Docket Item # 19-C  
DEVELOPMENT SPECIAL USE PERMIT #2003-0013  
West Glebe Road Townhouses

Planning Commission Meeting  
October 7, 2003

**ISSUE:** Consideration of a request for a development special use permit, with site plan, for construction of twenty-four townhomes in a cluster development plan with site plan modifications.

*Revised proposed site plan*

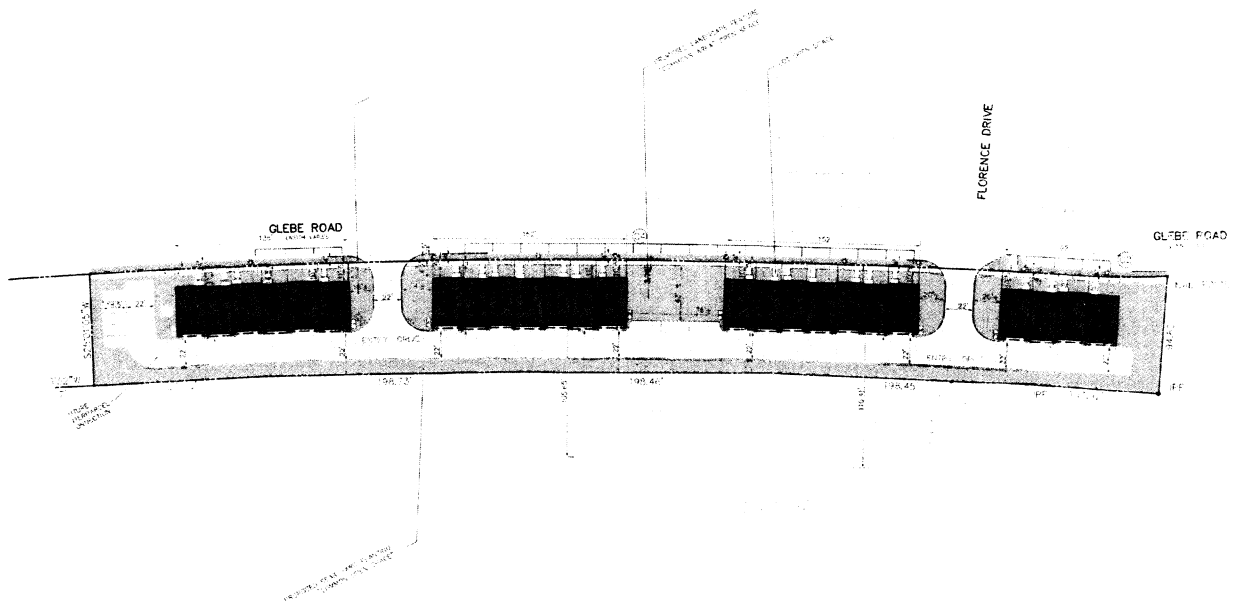
The original cluster development layout included townhouse units grouped into four buildings, with the curb cuts at each end of the development row, and the common open space divided into three areas between the four buildings plus two areas at each end of the site. While this arrangement was logical and orderly, it did not work to consolidate the open space into the largest possible area, so that they would be as attractive and usable as possible. Working with staff, the developer made several changes to create what staff and the applicant believe is a better open space arrangement.

First, the applicant revised its plans to reduce the number of units from 28 to 24, thus allowing more of the site to be green. In addition, by adjusting building widths and the spacing between the groups of units, the applicant has been able to create a large open space area in the center of the development, which is 76 x 43 feet or 3,268 sq. ft in area, and which will be planted and contain benches and walkways. At the two points where the driveway goes between the townhouses to the rear of the site, the applicant has included open space areas that are 62 and 64 feet wide. Although

*Plan view of landscaped buffer*

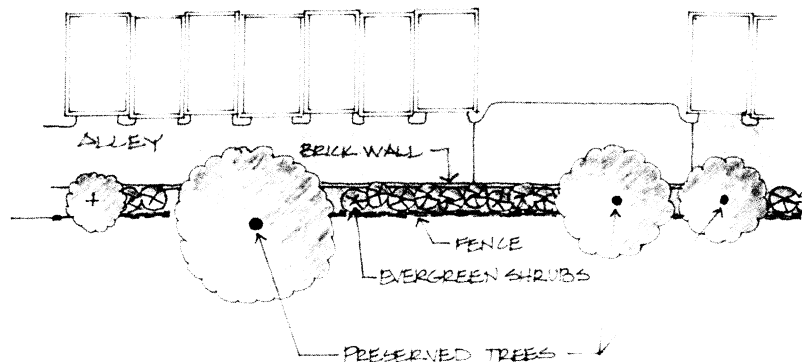
15. **(REVISED BY PLANNING COMMISSION)** As soon as practicable after relocation of utility lines, the ~~The~~ applicant shall construct an 8-foot high wooden fence with brick piers along the property line adjacent to the Tennessee Avenue properties as depicted in the preliminary site plan. Adjustments to the alignment of the fence shall be permitted, as necessary, to preserve trees identified on the tree preservation plan. The construction of the fence shall maintain the existing grade in the rear yards on Tennessee Avenue. Homeowners on Tennessee Avenue will be notified no less than seven (7) days before existing fencing is removed from their property and work on constructing each section of the new fence shall begin within three (3) days from the demolition of the existing fence at a time when it can be completed without undue delay. Before the existing fence is removed, a 6' to 8' high temporary chain link security fence along the rear of the site driveway shall be installed with an opaque privacy screen. The Homeowners Association shall maintain and repair all brick and wood fencing along the rear buffer zone, retaining a solid privacy/security screen without gaps. (P&Z) (PC)

Working closely with the North Ridge Citizens Association and with the individual homeowners on Tennessee Avenue who abut the property at the rear, the applicant has designed a treatment for the southern boundary line that buffers the new development as much as possible from the existing residential homes and apartments behind the development site. The site is approximately 850 feet long at its southern border. The rear border is heavily wooded, and includes a number of mature trees. The grade between the sites changes; the land to the south rises above the level of the parking lot.

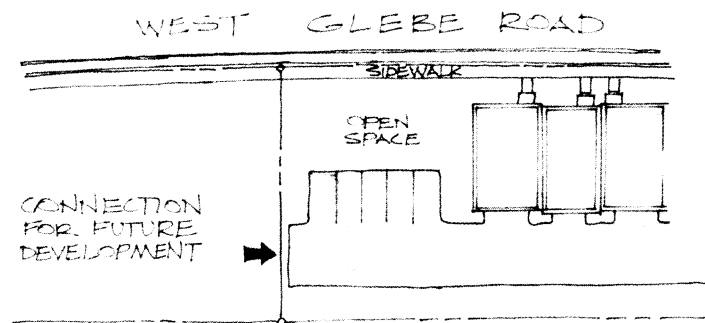
2. Revise the visitor parking on the western portion of the site to provide five 90 degree parking spaces that are perpendicular to the alley to provide additional open space adjacent to Glebe Road, and the alley shall be extended to the western property line to provide a future alley connection to the lot on the western portion of the site. A 3-3.5 ft. tall brick wall shall be provided on the western and northern portion of the site to the satisfaction of the Director of P&Z. Provide a detail of all walls and fences on the final site plan. (P&Z)

The visitor parking area is located at the western portion of the site, but at staff's suggestion, the applicant has agreed to redesign the area. The revised plan will retain the same number of spaces for visitors. However, by redesigning the end of the site, there will be adequate room to allow an extension of the rear drive aisle in the event that the adjacent parking lot site is developed in the future for townhouses. The reorientation of the units also enables the retention of additional open space and landscaping on the western portion of the site.

**Attachment 1**

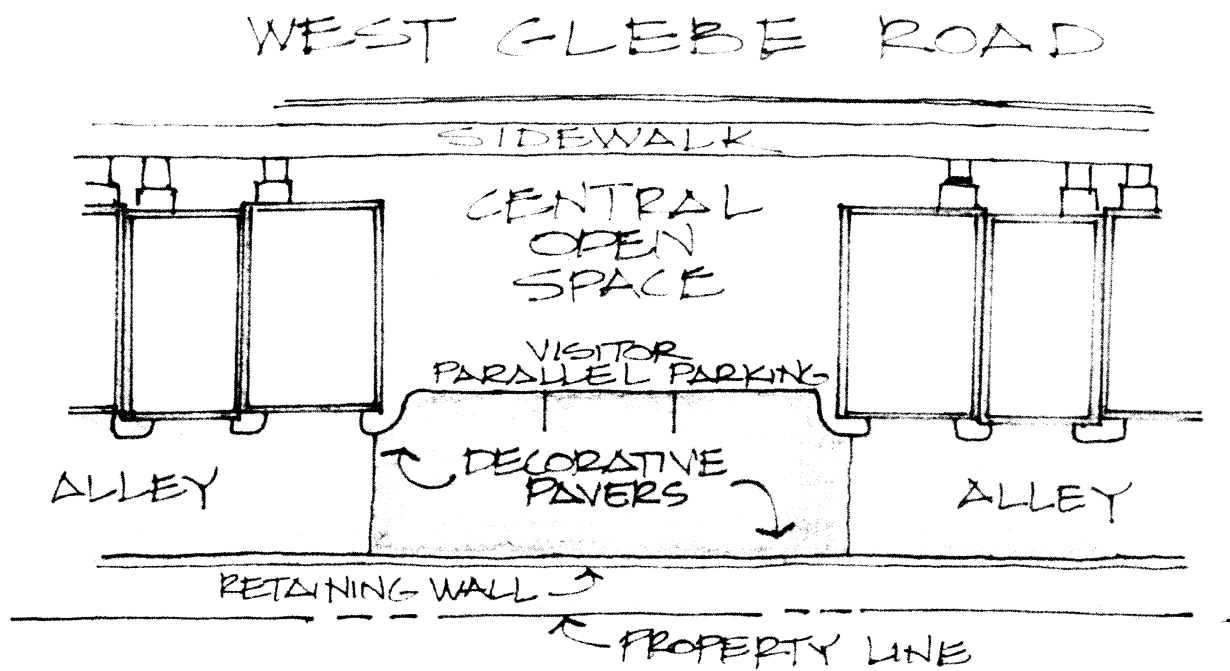
3. **(REVISED BY PLANNING COMMISSION)** ~~The three proposed parallel parking spaces adjacent to the central open space area shall be relocated to the eastern portion of the alley extension to the satisfaction of the Director of P&Z.~~ Raised decorative brick pavers shall be designed to continue the appearance of the central open space area as generally depicted in *Attachment No. 1.* (P&Z) (PC)
